Subject: **Request for Modification for Section 404 Regional General Permit No. 201902350 and Section 401 Water Quality Certification** for the Interstate 485 (I-485) improvements from I-77 to US 74 (Independence Boulevard), Mecklenburg County, Division 10, TIP I-5507. Debit \$570.00 from WBS 43609.3.2.

The purpose of this letter is to request modification of the United States Army Corps of Engineers (USACE) Section 404 Regional General Permit 201902350 (RGP 50) and associated North Carolina Division of Water Resources (NCDWR) Section 401 Water Quality Certification for the above referenced project.

**PERMIT DRAWING
SHEET 1 OF 115**

**PERMIT DRAWING
SHEET 12 OF 115**

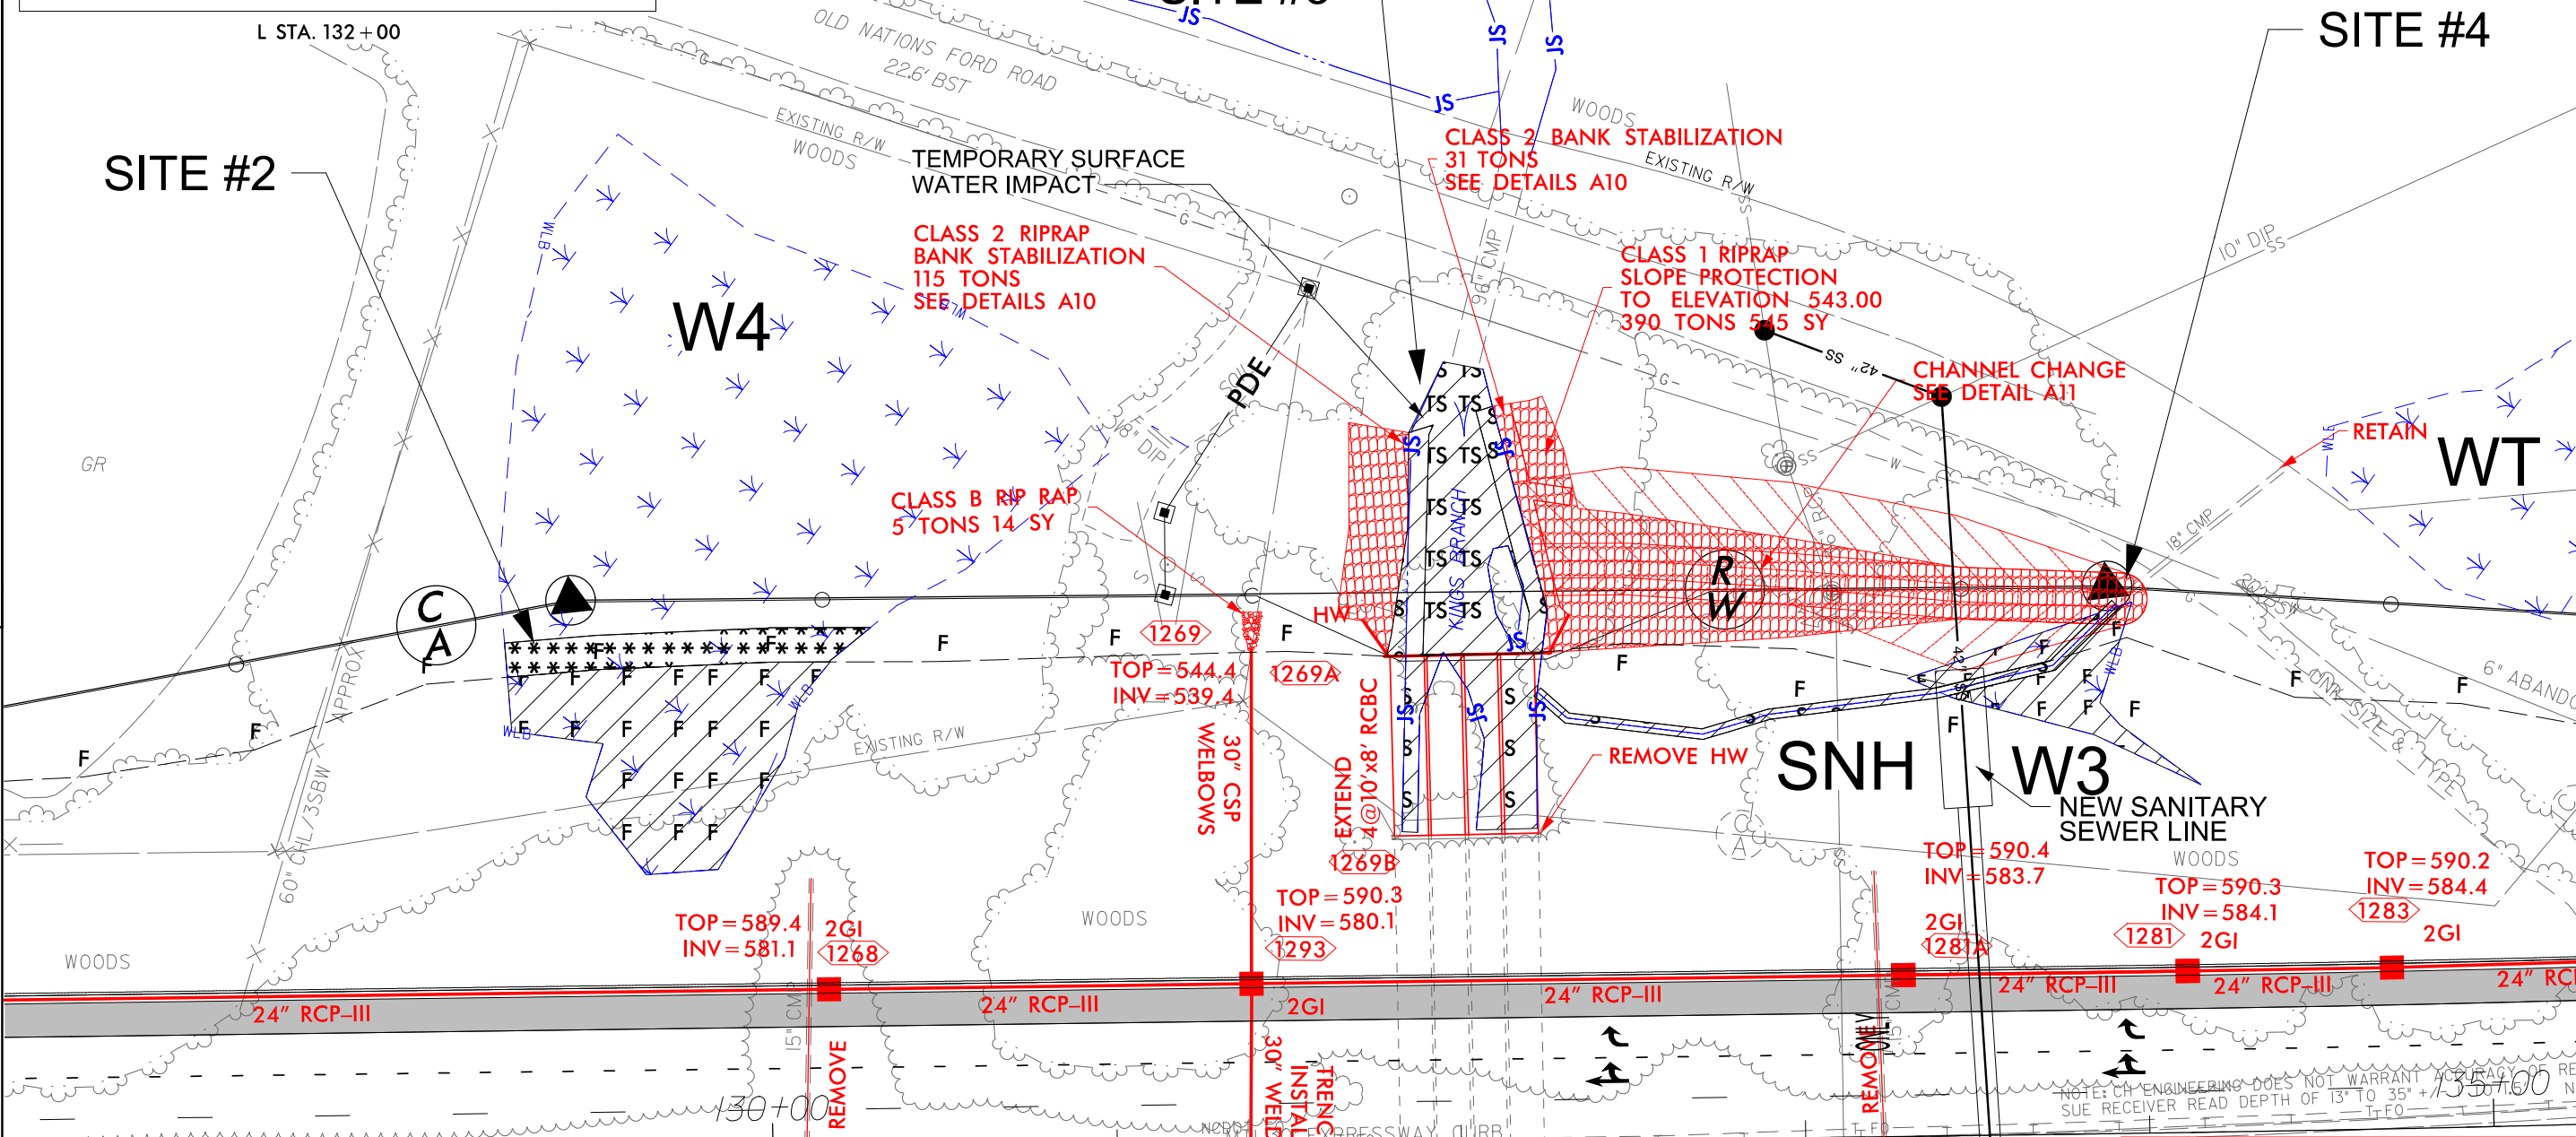
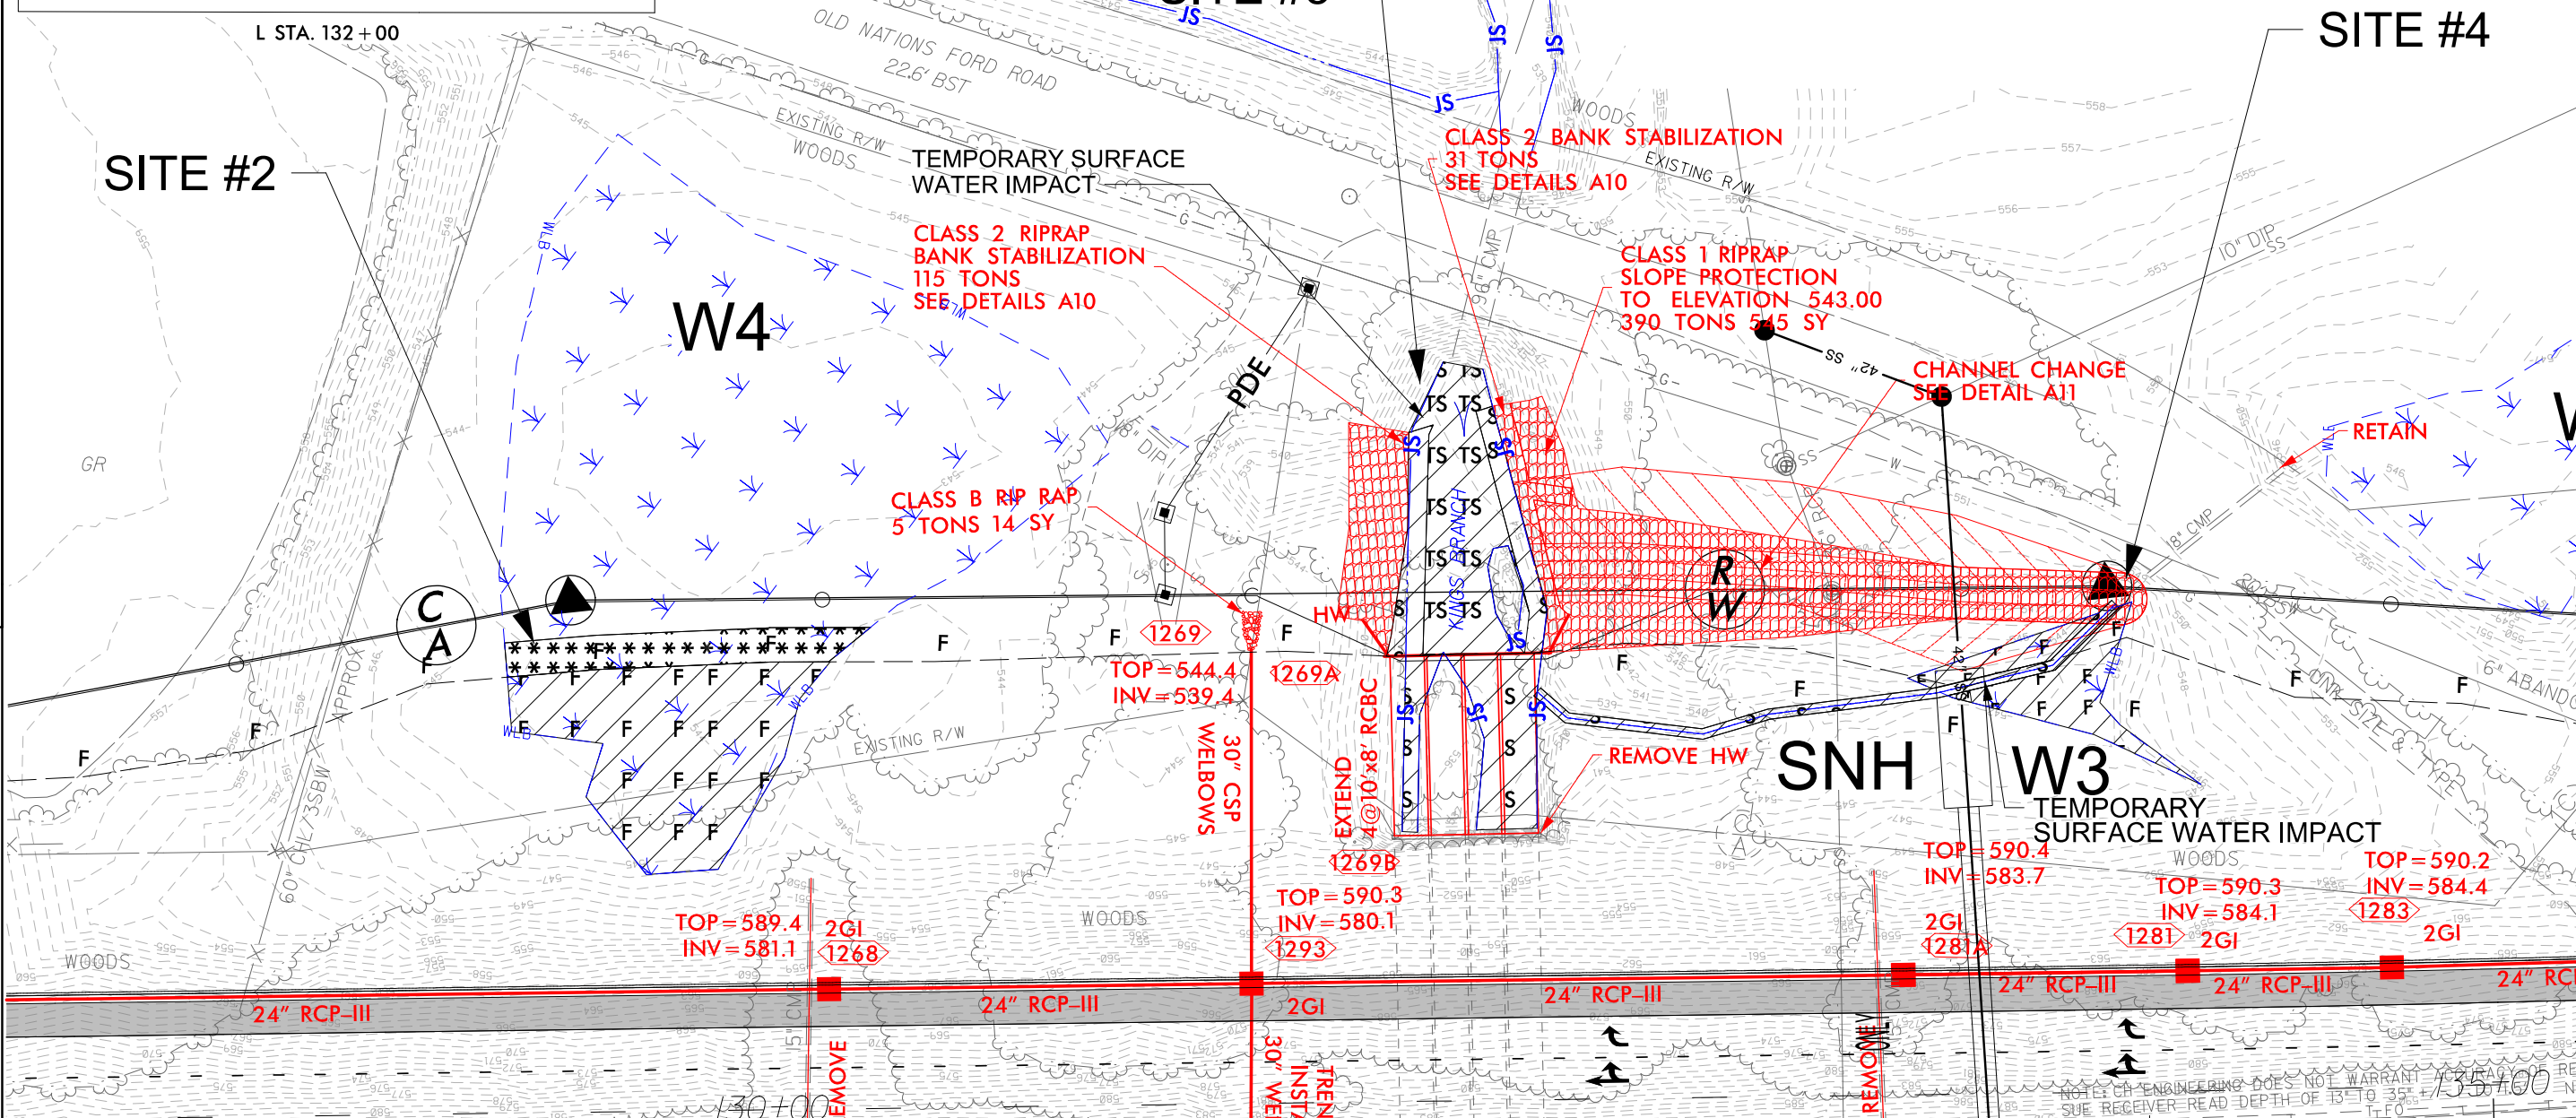
A permit modification was approved for this site on November 12, 2020 that included design revisions to the originally permitted roadway fill slopes and channel change in this location to avoid impacting the existing sanitary sewer line. It has since been determined that the sanitary sewer line will need to be replaced; therefore, the proposed design will revert to a 2:1 roadway fill slope as was included in the original permit (approved by the USACE on December 18, 2019 and NCDWR on December 2, 2019). The previous permitted design shown in the permit modification included <0.01 acre of permanent wetland fill impacts due to roadway fill, <0.01 acre of permanent wetland fill impacts due to the channel change, and 0.02 acre of mechanized clearing impacts to wetland W3. Stream impacts totaled 130 linear feet of permanent stream channel impacts, including 95 linear feet due to roadway fill and 35 linear feet due to the channel change,

as well as 10 linear feet of temporary fill impacts to stream SNH. The proposed design will result in a total of 181 linear feet of permanent stream channel impacts to stream SNH, including 159 linear feet due to roadway fill and 22 linear feet due to the channel change, and no temporary stream impacts. Proposed wetland impacts will be 0.03 acre, including 0.02 acre of permanent wetland fill impacts due to roadway fill, <0.01 acre of permanent wetland fill impacts due to the channel change, and no mechanized clearing impacts in wetlands. The proposed design will result in an increase in permanent stream channel impacts of 51 linear feet and a decrease in temporary stream impacts of 10 linear feet. Overall total permanent wetland impacts to wetland W3 will remain 0.03 acre, although permanent wetland fill impacts have been increased to 0.03 acre and mechanized clearing impacts have been eliminated.

PERMIT DRAWING SHEET 28 OF 115

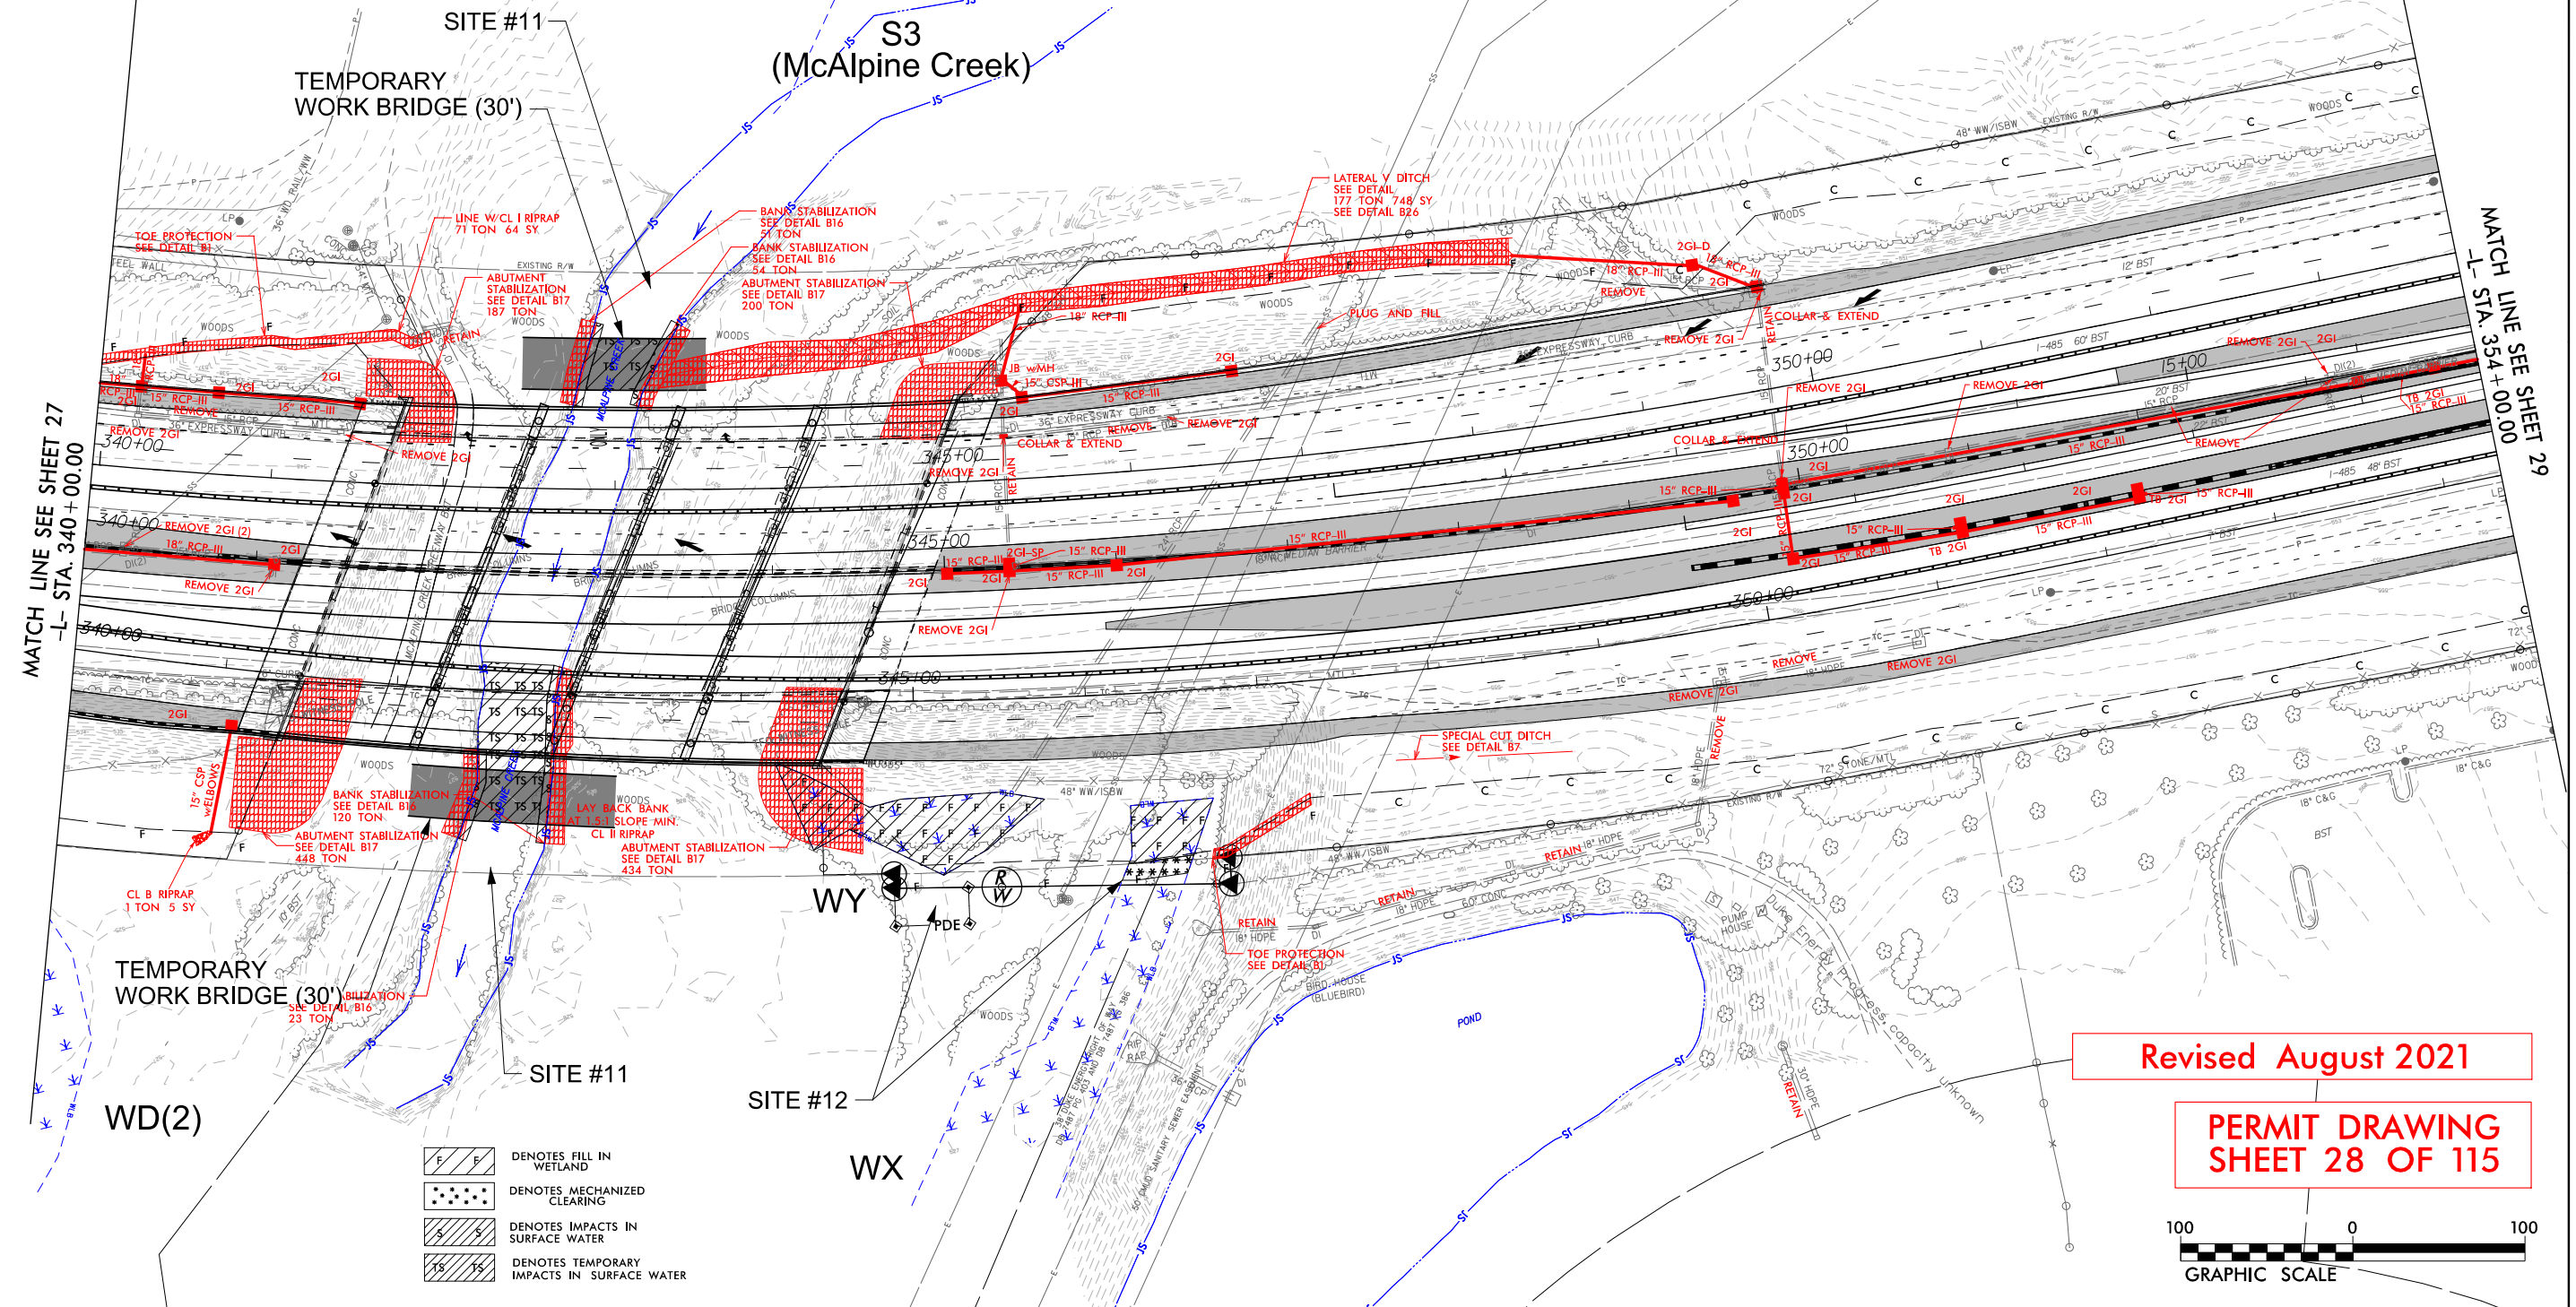
In addition, permitted impact Sites 11 and 12 are included in the revised permit drawings to highlight the changes to the drainage design from previously approved permit drawings. The design changes at Sites 11 and 12 will not result in any changes to the amount or type of permitted impacts and are not discussed further.
